Purchasing Department

Subject: Invitation to Bid #1536-B: Stonewall TPO Roof - Addendum #1

DETAIL NO.
UT-E-9

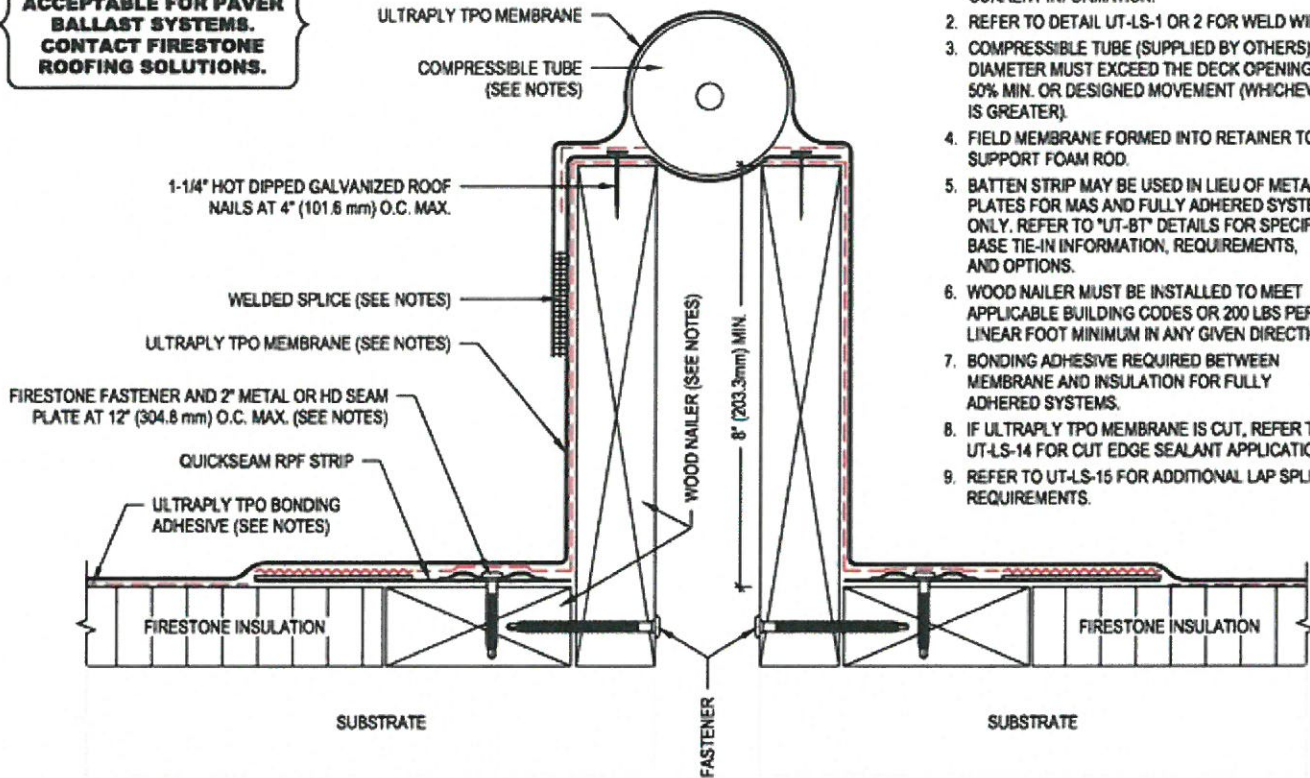
- 11. The existing expansion joint (curb to curb) has been coated and ability of the bellows to move with the roof is compromised. Are you replacing the expansion joint?**
Only if necessary due to damage. Otherwise, remove existing ply membrane and recover existing curb & compressible tube with new membrane as noted in the Firestone Detail UT-E-9. Replacing the expansion joint will be determined once the EPDM / TPO membrane is removed. A line item will be added to account for replacement of the expansion joint (compressible tube).
